QUALITY ASSURANCE -- NON-CONFORMANCE REPORT

Report No: NCR-000431

Reference Description: Missed UT transverse indications by QC on 1AAW/1AW Segment Transverse Splice

Job Name: SAS Superstructure

1AAW- 1AW Edge Panel CB Side

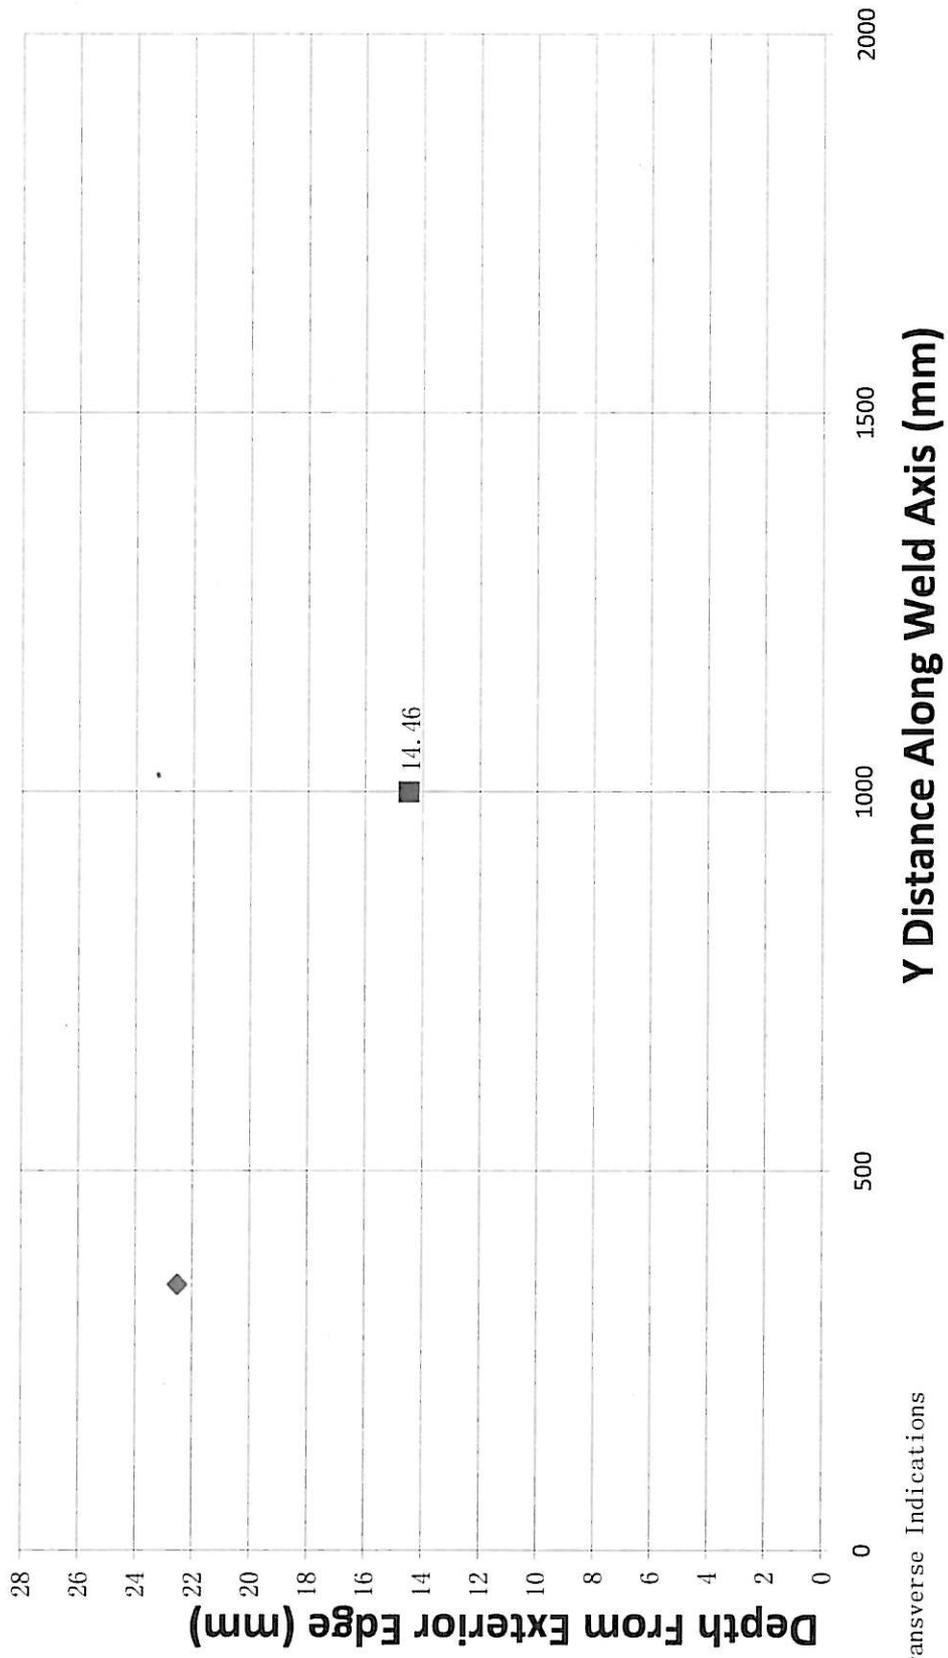
LAW to1AAW
OBW1-003
Edge Panel (Cross Beam Side)

Ind. No.	Date	Lot #	Scanning Pattern	Angle in Deg.	Sound Path(mm)	Depth (mm)	A	B	C	D	Class	Thickenss (mm)	Length (mm)	REJ.	Distance From X (mm)	Distance From Y (mm)	Indication Orientation
1	21-Oct-09	B288	D	70	65.79	22.5	77.5	58.8	3	16		28	39		0	350	T
2	21-Oct-09	B288	B	70	42.3	14.46	81.9	58.8	1	22		28	25		0	1000	L

1AAW - 1AW Edge Panel CW Side

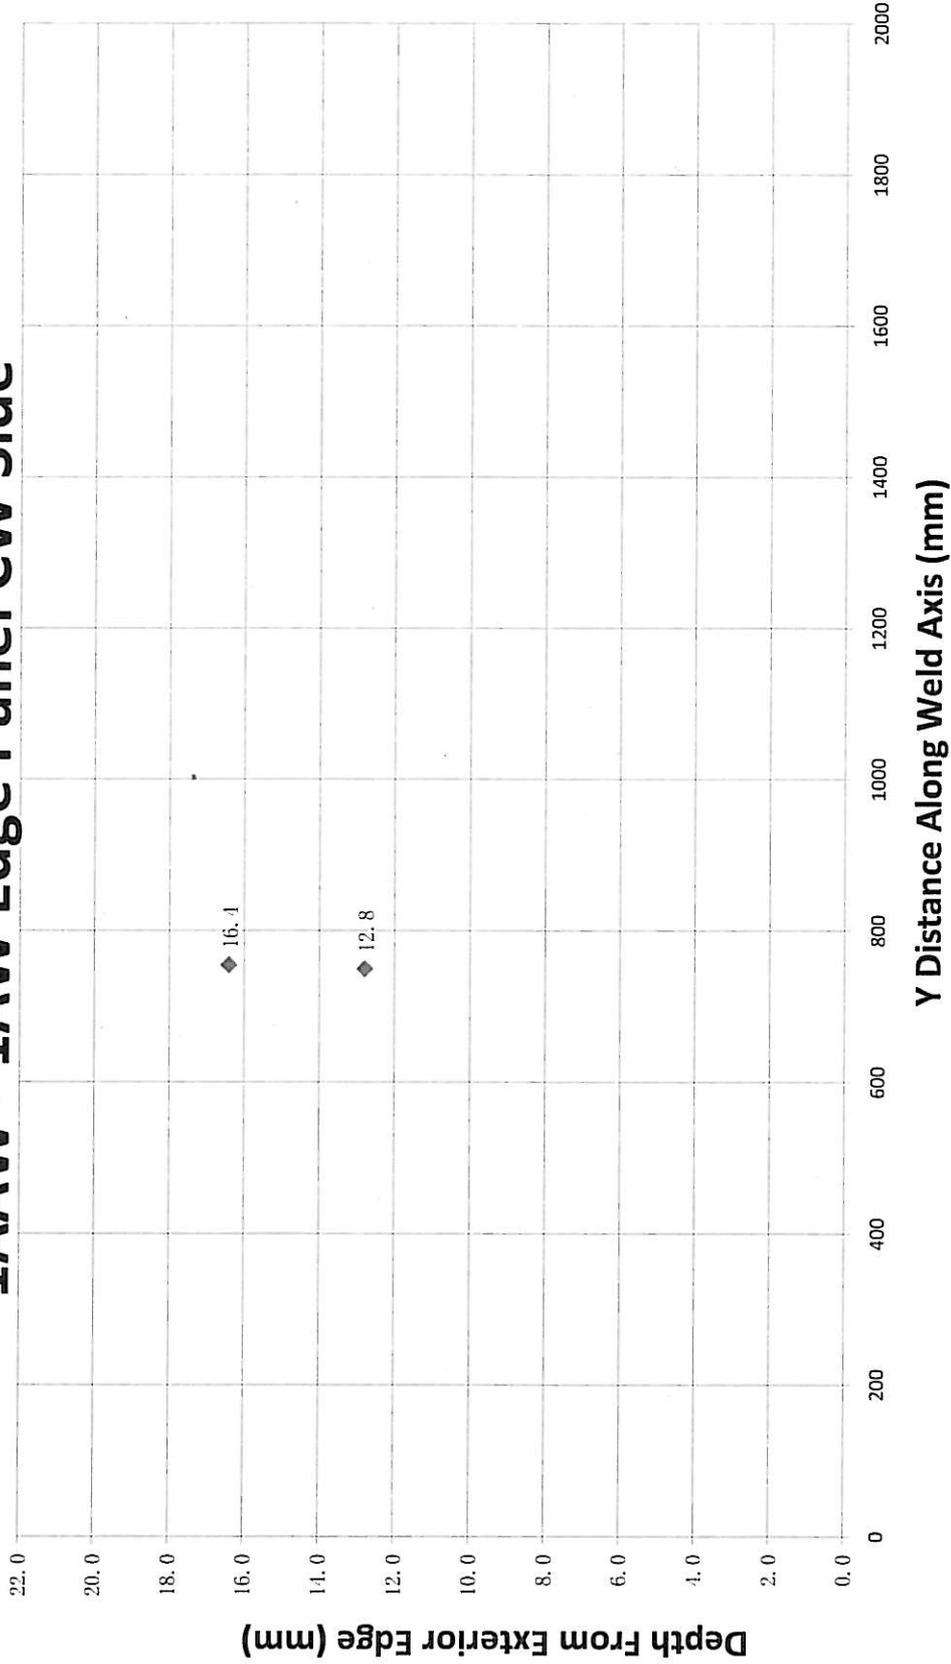
IAW toIAAW
OBWI-002
Edge Panel (Counter Weight Side)

Ind. No.	Date	Lot #	Scanning Pattern	Angle	Sound Path	Depth	A	B	C	D	Class	Thk. (mm)	Length	REJ.	Distance From X	Distance From Y	Indication Orientation	Comments (Surface and Ecl.)	
1	19-Oct-09	B277	D	70	37.4	12.8	64	53	1	10	D	22	8		0	750			
2	19-Oct-09	B277	D	70	47.93	16.4	69	53	1.8	14	D	22	6		0	755

1AAW - 1AW Bottom Plate

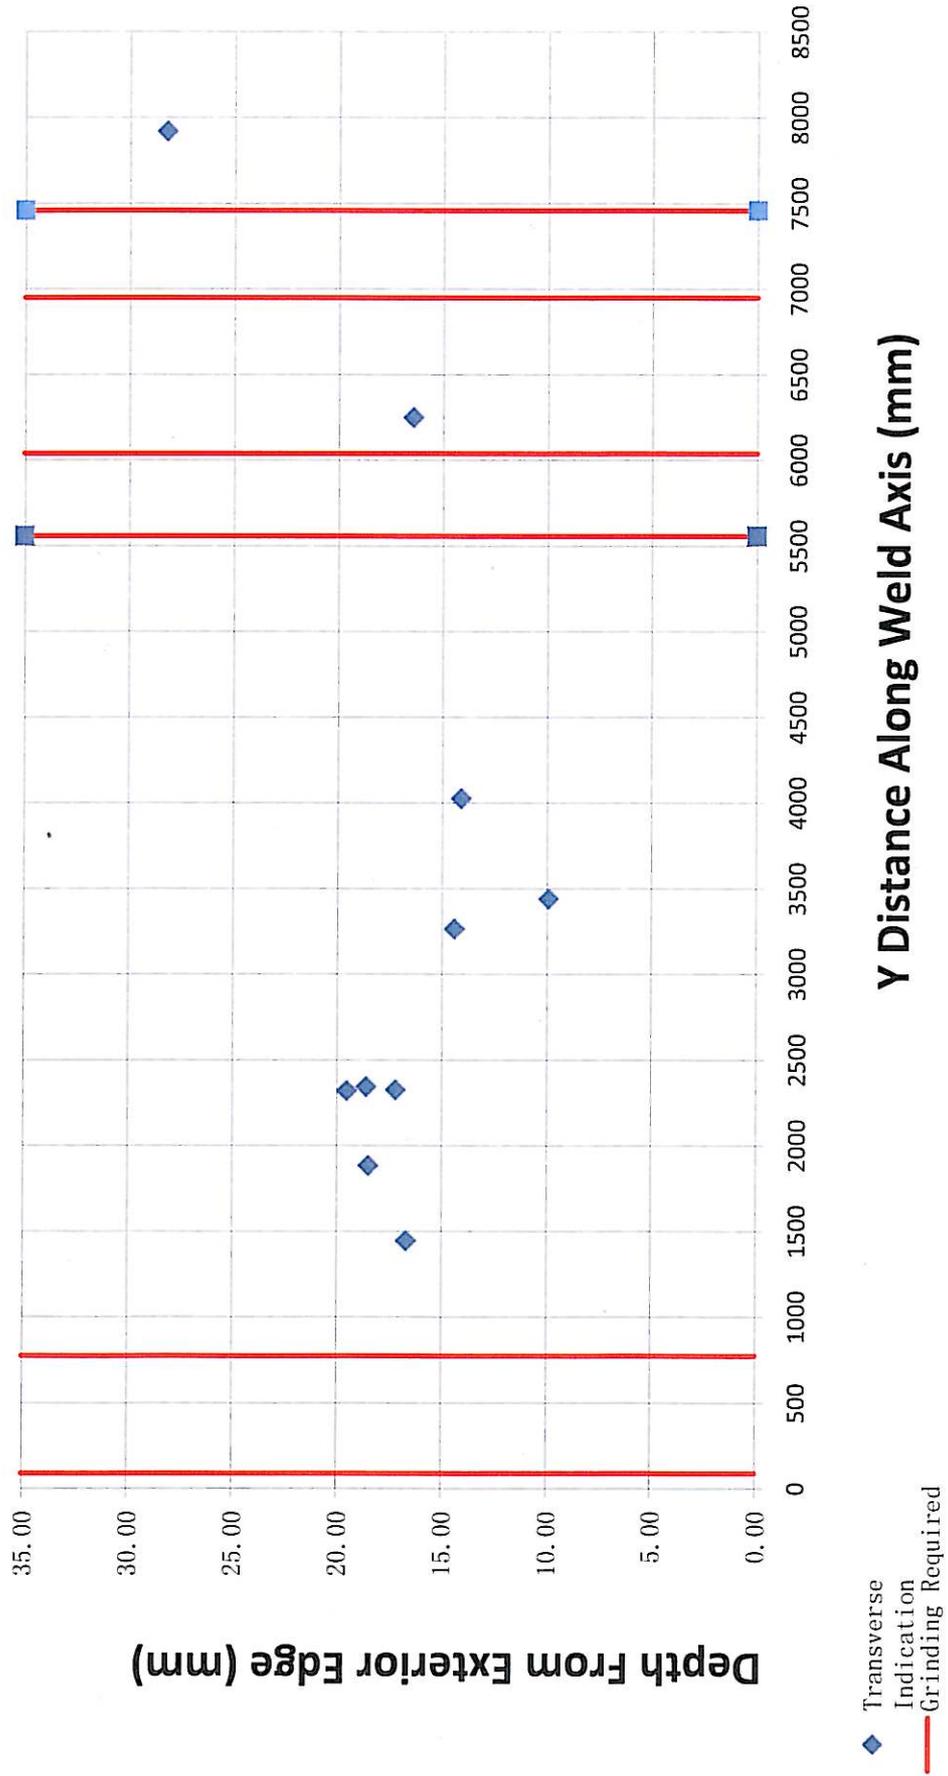
1AW to 1AAW
OBWIA-003
Bottom Panel

Ind. No.	Date	Lot #	Scanning Pattern	Angle in Deg.	Sound Path (mm)	Depth (mm)	A	B	C	D	Class	Thickenss (mm)	Length (mm)	REF.	Distance From X (mm)	Distance From Y (mm)	Indication Orientation	Comments (Surface Condition and Ect.)
1	23-Oct-09	B264	D	70	48.8	16.69	76.00	51	1.90	23		35	10			1446	T	
2	23-Oct-09	B205	D	70	54.1	18.50	76.00	51	2.33	23		35	8			1885	T	
3	23-Oct-09	B205	D	70	57.1	19.53	77.00	51	2.57	23		35	10			2320	T	
4	23-Oct-09	B205	D	70	50.3	17.20	77.00	51	2.02	24		35	10			2325	T	
5	23-Oct-09	B205	D	70	54.4	18.60	76.00	51	2.35	23		35	8			2345	T	
6	23-Oct-09	B264	D	70	42.1	14.40	76.00	51	1.37	24		35	10			3265	T	
7	23-Oct-09	B205	D	70	28.97	9.91	74.00	51	0.32	23		35	8			3440	T	
8	23-Oct-09	B205	D	70	41.2	14.09	73.00	51	1.30	21		35	10			4025	T	
9	23-Oct-09	B264	D	70	48.1	16.45	75.00	51	1.85	22		35	10			6250	T	
10	23-Oct-09	B205	D	70	82.5	28.22	76.00	51	4.60	20		35	8			7920	T

1AAW - 1AW Side Panel CW Side

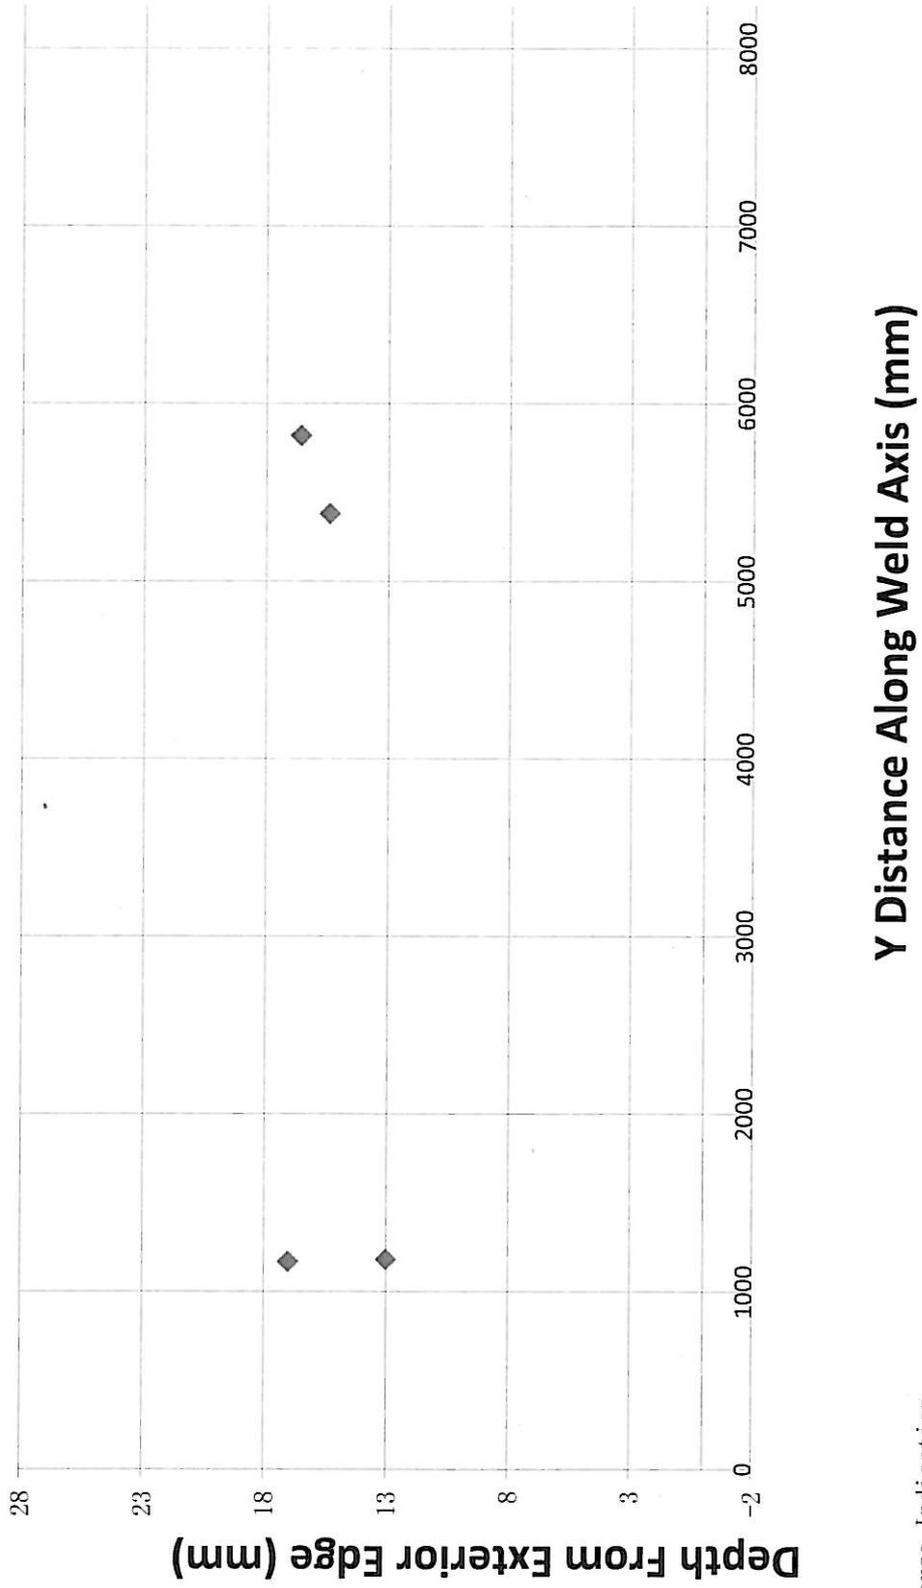
IAW to IAAW
OBWIA-002 and OBWIA-001
Side Panel (Counter Weight Side)

Ind. No.	Weld ID	Date	Lot #	Scanning Pattern	Angle in Deg.	Sound Path (mm)	Depth (mm)	A	B	C	D	Class	Thickenss (mm)	Length (mm)	REJ.	Distance From X (mm)	Distance From Y (mm)	Indication Orientation	Comments (Surface Condition and Ecl.)
1	OBWIA-001	19-Oct-09	B277	D	70	-	-	-	-	-	-	-	22						ACC
4	OBWIA-002	19-Oct-09	S004	D	70	51.3	17	68	50	2	16	D	28	5			1168	Trans.	-
5	OBWIA-002	19-Oct-09	S004	D	70	39.8	13	61.6	50	1	11	D	28	6			1182	Trans.	-
2	OBWIA-002	19-Oct-09	S003	D	70	41	15	74.8	54	1	20	D	28	4			5380	Trans.	-
3	OBWIA-002	19-Oct-09	S003	D	70	44	17	74.7	54	2	19	D	28	5			5820	Trans.	-

1AAW - 1AW Side Panel OBW1A-004

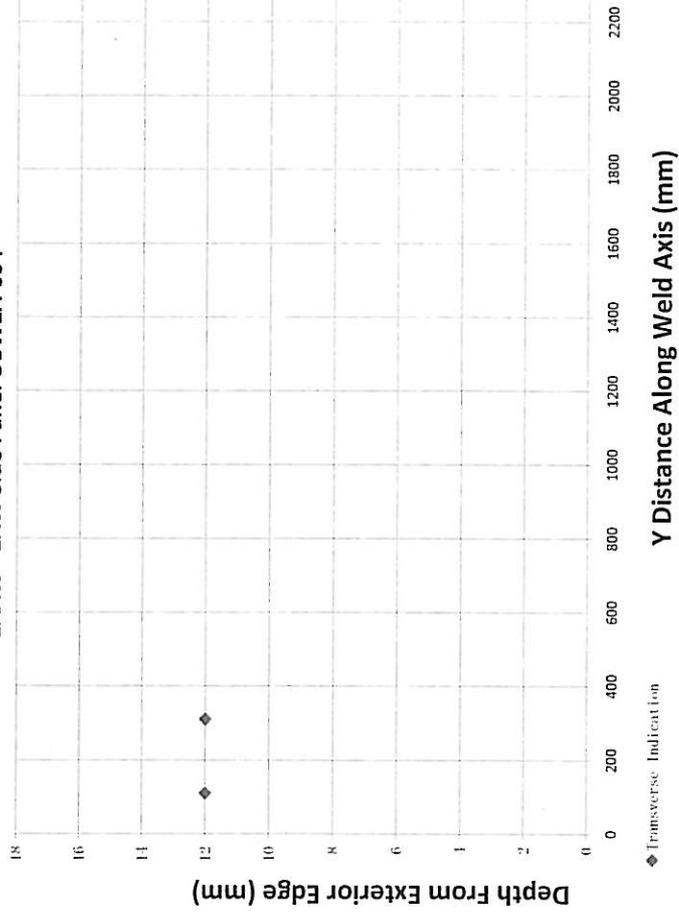
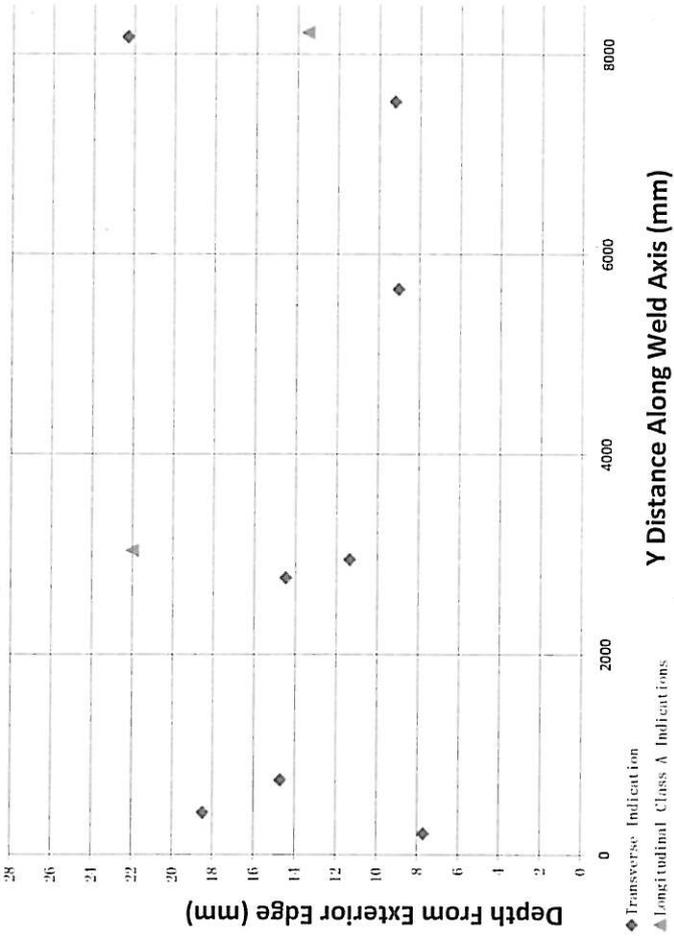
SEGMENT IAAW to IAW
 WELD No. OBWIA-004, 005
 LOCATION Side Panel (Crossbeam side)

Ind. No.	Weld ID	Date	Weld No.	Lot #	Scanning Pattern	Angle in Deg.	Sound Path (mm)	Depth (mm)	A	B	C	D	Class	Thickenss (mm)	Length (mm)	REJ.	Distance From X (mm)	Distance From Y (mm)	Indication Orientation
1	OBWIA-005	22-Oct-09	OBWIA-005	B264	D	70	37	12	69	51	1	17		18	10			111	Trans.
2	OBWIA-005	22-Oct-09	OBWIA-005	B264	D	70	37	12	73	51	1	21		18	10			310	Trans.
1	OBWIA-004	23-Oct-09	OBWIA-004	B205	D	70	26.5	9	71	51	0	20	D	28	8		0	5650	Trans.
2	OBWIA-004	23-Oct-09	OBWIA-004	B205	D	70	26.9	9	69	51	0	18	D	28	9		0	7525	Trans.
3	OBWIA-004	23-Oct-09	OBWIA-004	B205	D	70	65.4	22	73	51	3	19	D	28	10		0	8175	Trans.
4	OBWIA-004	23-Oct-09	OBWIA-004	B205	B	70	39.4	13	58	51	1	6	A	28	10	REJ	0	8220	Long.
5	OBWIA-004	22-Oct-09	OBWIA-004	B205	D	70	23.7	8	69	51	0	18		28	10			210	Trans.
6	OBWIA-004	22-Oct-09	OBWIA-004	B205	D	70	57.0	18	75	51	3	21		28	5			420	Trans.
7	OBWIA-004	22-Oct-09	OBWIA-004	B205	D	70	45.3	15	75	51	2	22		28	8			745	Trans.

8	OBWIA-004	22-Oct-09	OBWIA-004	B205	D	70	44.6	14	76	51	2	23		28	8			2765	Trans.
9	OBWIA-004	22-Oct-09	OBWIA-004	B205	D	70	35.0	11	66	51	1	14		28	10			2945	Trans.
10	OBWIA-004	22-Oct-09	OBWIA-004	B205	B	70	67.8	22	61	51	3	7	A	28	15	REJ		3035	Long.
